**AGENDA
CITY OF CEDAR FALLS, IOWA
PLANNING AND ZONING COMMISSION MEETING
WEDNESDAY, DECEMBER 22, 2021
5:30 PM AT CITY HALL**

TO: Planning and Zoning Commission
FROM: Michelle Pezley, Planner III
Matt Tolan, PE, Civil Engineer
DATE: December 3, 2021 updated December 17, 2021
SUBJECT: West Viking Road Industrial Park Phase V and VI Preliminary Plat (PP21-007)

TO: Planning & Zoning Commission
FROM: Stephanie Houk Sheetz, AICP, Director of Community Development
DATE: December 15, 2021
SUBJECT: River Place Plaza Site Plan Amendment (Lot 3 River Place 3rd Addition) (SP21-017)

TO: Planning & Zoning Commission
FROM: Stephanie Houk Sheetz, Director of Community Development
DATE: March 4, 2020
SUBJECT: Site Plan Review for the Plaza at River Place Properties

- **Trash Receptacles**

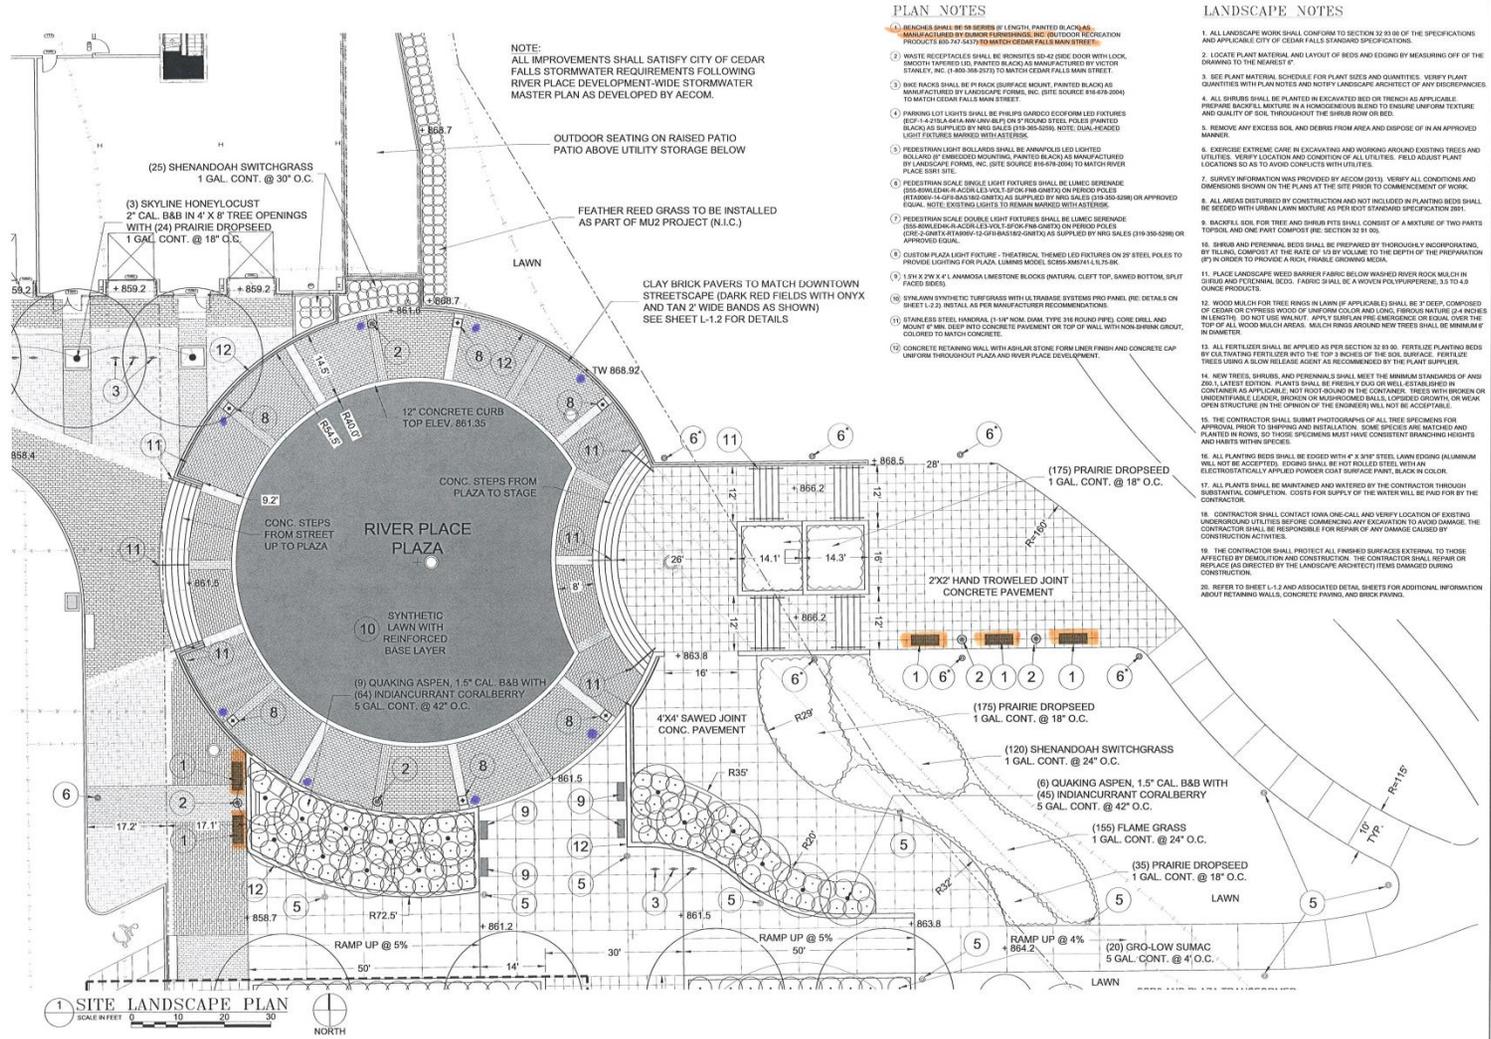
The 2016 site plan shows 13 black benches by Dumor, matching the downtown benches. It is proposed that a movable table/chair combination be placed within the Plaza. This seems reasonable. A table/chair offering would encourage lunches and meetings, contributing to the Plaza's ambiance. The stairs connecting the public sidewalk to the Plaza drives re-locating or removing several benches. However, the same total quantity is proposed: 8 table/bench combinations and 5 benches. The following pages provide comparison drawings from 2016 site plan to the proposed plan.

The developer has agreed to move one bench at the top of the stairs from the south side to the north side. This would better balance the benches found on the south side in that location.

The 2016 site plan included seven trash receptacles, partnered with bench locations. The current plan includes five. The Plaza area includes two trash cans. The change is not substantial and is related to the change in bench locations.

Staff recommends approval of the changes.

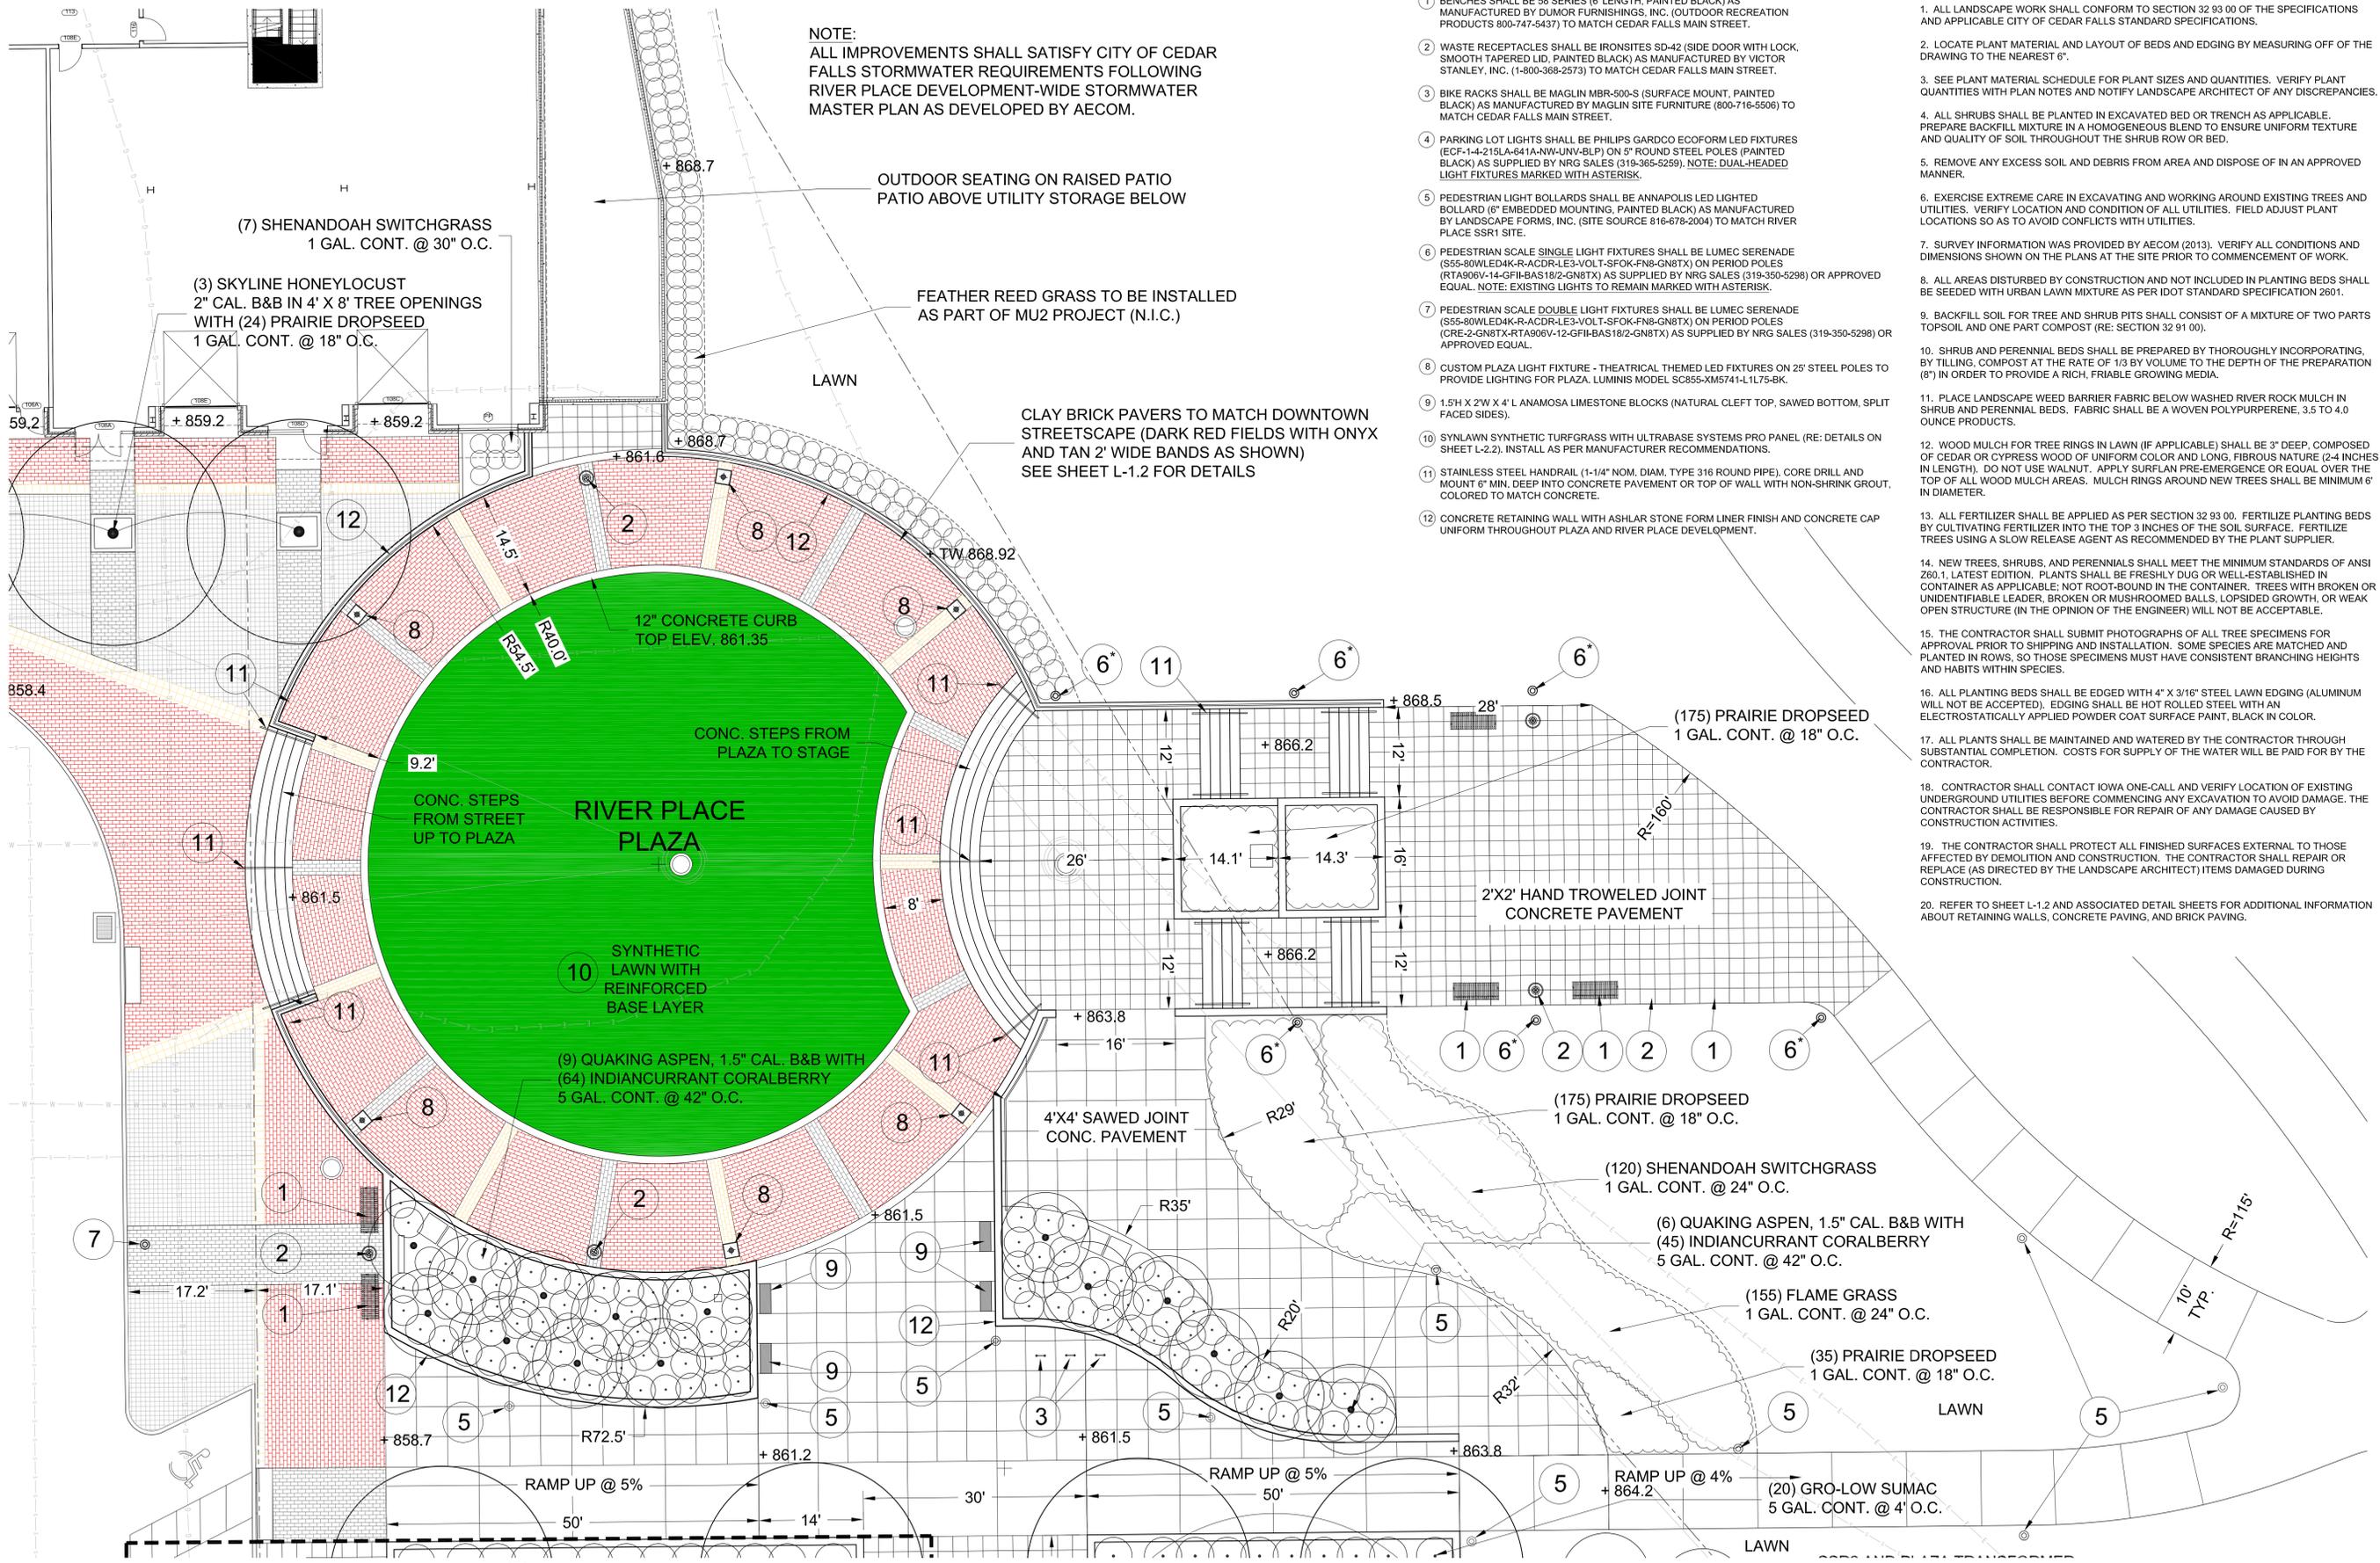
- a. Connection of existing 24" + proposed 15" RCP could create conflict at storm structure with approach angles. Please review and verify the clearance.
- b. Show ADA ramp flairs on details, meeting ADA Chapter 4.
- c. Submit SWPPP and ROW Permits prior to commencing work.

1. Change single-head Lumec Serenade light at southeast corner of 2nd/State St. intersection to a double head light, complementing the one currently at the northeast corner.
2. Move a decorative bench at the top of the stairs, from the south side to the north side.
3. Use U-shaped bike racks.
4. Complete restroom facilities, by July 1, 2021 unless amendments to the Development Agreement provide an alternative timeline.
5. All signage will require a permit. At that time, verification of Development Agreement terms and compatibility with the downtown will be reviewed.
6. Revise Development Agreement to include 2020 site plan.

7. Public access easements will be provided as outlined in the Development Agreement and amendments thereto.
8. All technical review comments must be met.
